ADMINISTRATIVE AMENDMENT (PD) ADD2013-00019

ADMINISTRATIVE AMENDMENT
LEE COUNTY, FLORIDA

WHEREAS, Wal-Mart Stores East, LP filed an application for administrative approval to a Mixed Use Planned Development on a project known as Wal-Mart 5347-00 (Estero Golf Resort MPD) for :

Amendment to
Master Concept Plan

ESTERO GOLF RESORT
MASTER CONCEPT PLAN
"WAL-MART OPTION"

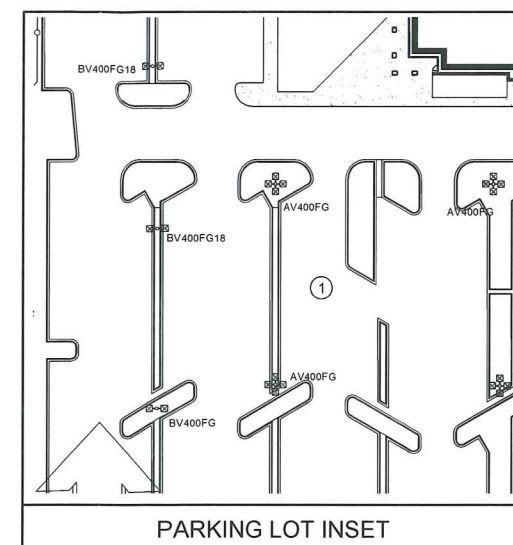
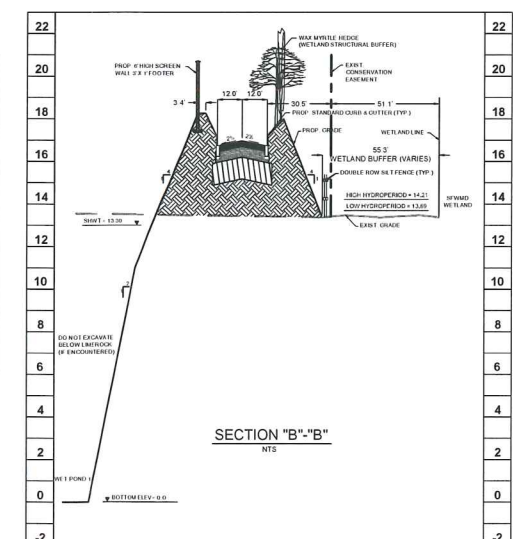
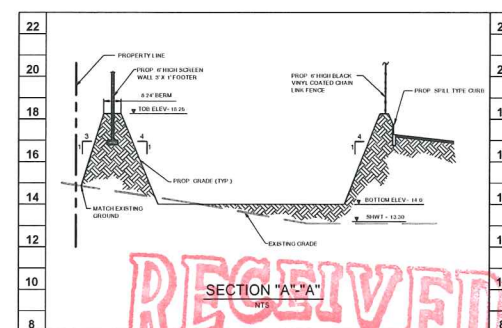
1. PARKING WITHIN COMMERCIAL TRACT MPD-1 WILL UTILIZE LINEAR CONCRETE ISLANDS IN LIEU OF WHEEL STOPS, AND COMBINE DIFFERENT ANGLES OF PARKING SPACES WITHIN ONE AND TWO WAY DRIVE AISLES TO MINIMIZE UNNECESSARY PAVEMENT (SEE INSET).
2. THE REDUCTION OF THE REQUIRED SETBACK TO 28.50 FT FOR EXCAVATIONS FROM ROAD RIGHT OF WAY TO LAKES (LDC 10-329).
3. THE REVISION OF THE REQUIRED SETBACK TO 46.25 FT FOR EXCAVATIONS FROM THE EASTERN PROPERTY LINE TO LAKES (LDC 10-329).

MASTER CONCEPT PLAN CHANGES (EXHIBIT IV - J - 1, VI - J - 3)

1. THE OFFICE TRACT MPD-2 AND COMMERCIAL TRACT MPD-4 SHOWN ON THE EXISTING APPROVED MASTER PLAN IS DELETED.
2. THE LOCATION OF THE INTERIOR ACCESS ROAD IS MODIFIED AS SHOWN FROM THE EXISTING APPROVED MASTER PLAN.

3. THE LOCATION OF THE DRIVEWAY CONNECTION TO U.S. 41 IS MODIFIED AS SHOWN, PER FDOT RECOMMENDATIONS, FROM THE EXISTING APPROVED MASTER PLAN.
4. THE SCHEDULE OF USES FOR TRACT MPD-1 IS MODIFIED TO INCLUDE DRUG SALES (PHARMACY), HARDWARE STORE, AUTO PARTS STORE, AND AUTOMOBILE REPAIR AND SERVICE.

5. COMMERCIAL TRACTS MPD-1 AND MPD-3 HAVE NO RESTRICTIONS ON HOURS OF OPERATIONS.
6. PROHIBITION ON DELIVERIES BETWEEN 8 PM AND 6 AM ON COMMERCIAL TRACTS MPD-1 AND MPD-3 ARE MODIFIED TO PROHIBITION ON DELIVERIES BETWEEN 8 PM AND 4 AM.

7. THE LOCATION AND NUMBER OF DRY DETENTION PONDS AND LAKES (WET DETENTION PONDS) ARE MODIFIED AS SHOWN.
8. THE PROPOSED SIDEWALK IS TO BE LOCATED WITHIN THE US 41 AND ESTERO PARKWAY RIGHT-OF-WAY ON THE EXTERIOR OF THE PROPOSED BUFFER.
